APPENDIX E

CORRESPONDENCE

DREDGED MATERIAL MANAGEMENT PLAN
MILWAUKEE HARBOR, WISCONSIN

Cell Design and Operation Information for the Proposed Great Lakes Legacy Act Project at the Kinnickinnic River in Milwaukee, Wisconsin

Figure 1

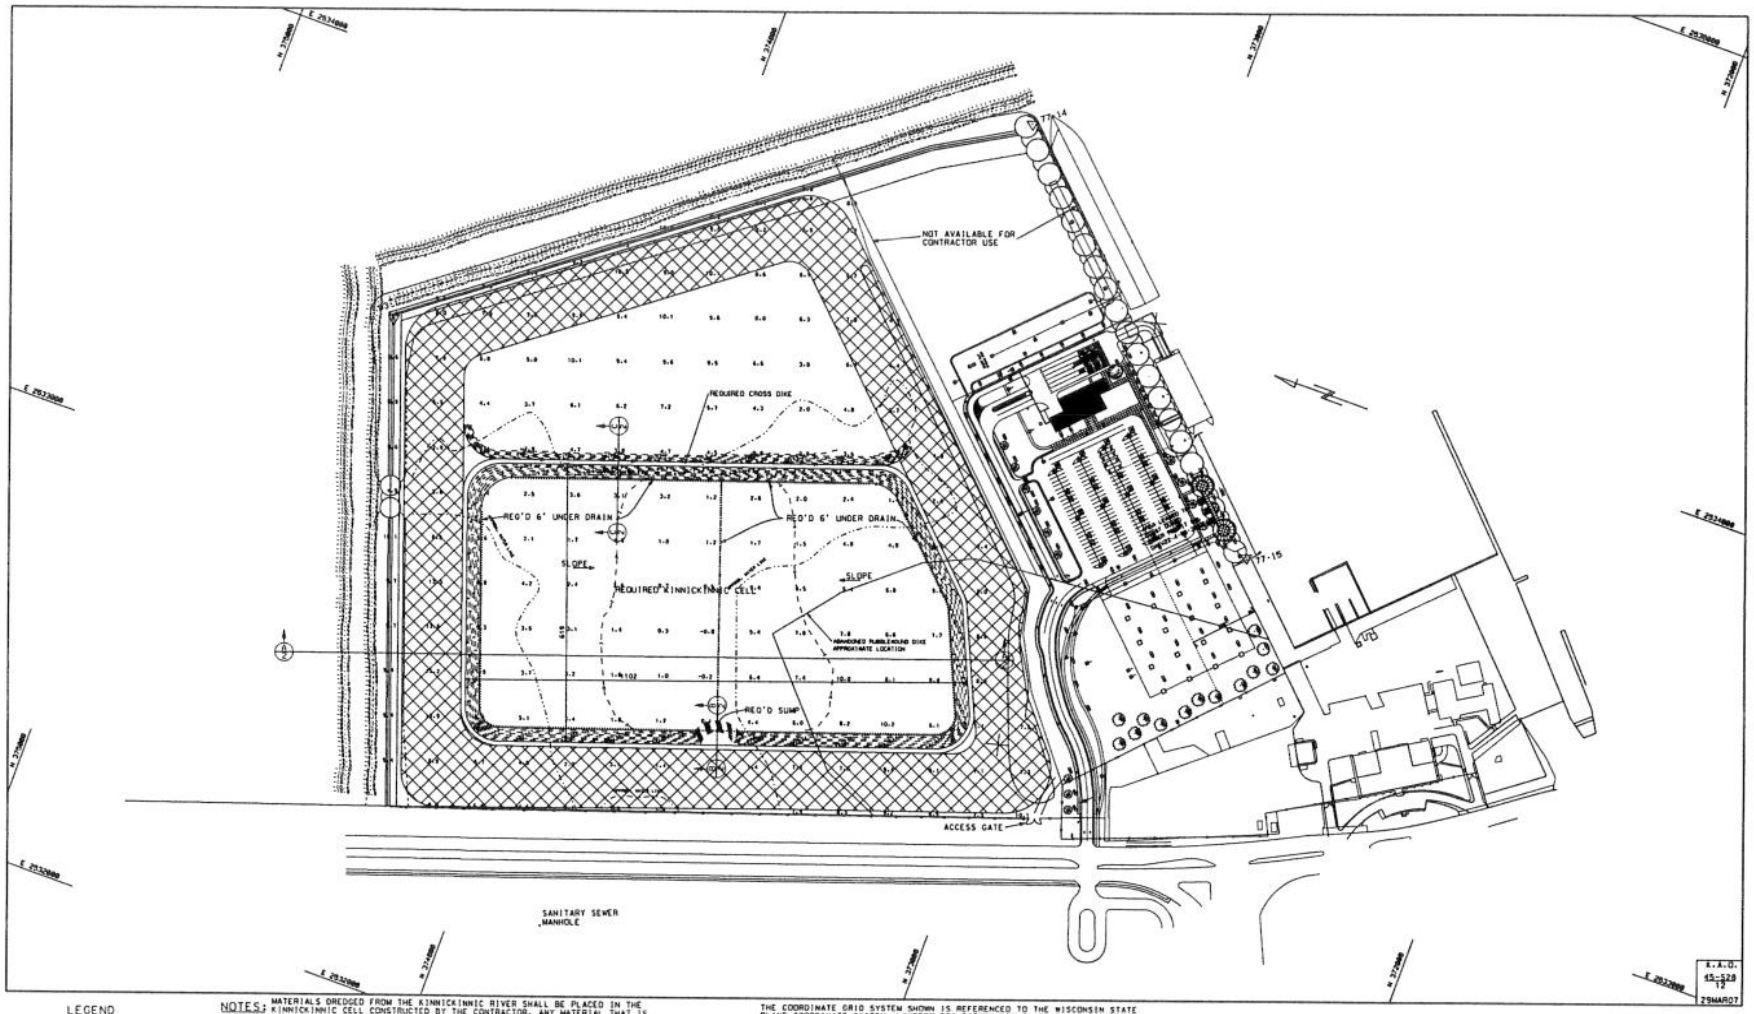
> The interim and final cover cap. The cover needs to be placed within 30 days of the completion of dredging [NR 506.08(3)]. If the cap is not impervious then a leachate collection system needs to continue to operate until an impervious cap is placed. The Department will accept the future dredging as the final cover if it exceeds three feet in depth with minimum 2% slope on the top. The leachate collection will continue until such requirement is met.

There would be a minimum of 100 feet of this impermeable dredged material between Lake Michigan and the proposed cell (Figure 1). Currently the Milwaukee CDF has an upland area on the west side and a car ferry operation bordering the south side which provides a 300 foot buffer between the lake and the CDF. The east side of the cell is also at least 300 feet from the lake. The northernmost portion of the cell is approximately 100 feet from the lake however both the north and east perimeter dikes have an existing grout mattress liner within the CDF.

Up to 170,000 cubic yards of dredged sediment from the Kinnickinnic River is expected to be placed into the KK cell constructed in the western half of the CDF. The placement of this Kinnickinnic River material would bring the top elevation of the cell back up to +10.0 feet above LWD. The top of the existing SSP walls on the west side of the CDF are at elevation +10.5 above LWD, the outer dike rubblemound structures on the north and east side of the CDF are at elevation +10 above LWD. Immediate capping of this material would be difficult due to the unconsolidated nature of the dredged material. The dredging and disposal operation would need to be modified to add a solidification agent. We would propose instead to allow the leachate collection system to operate for at least six months after the dredging operation has been completed. The Corps is preparing a Dredged Material Management Plan for the Milwaukee Harbor. One alternative under consideration would construct a new dredged
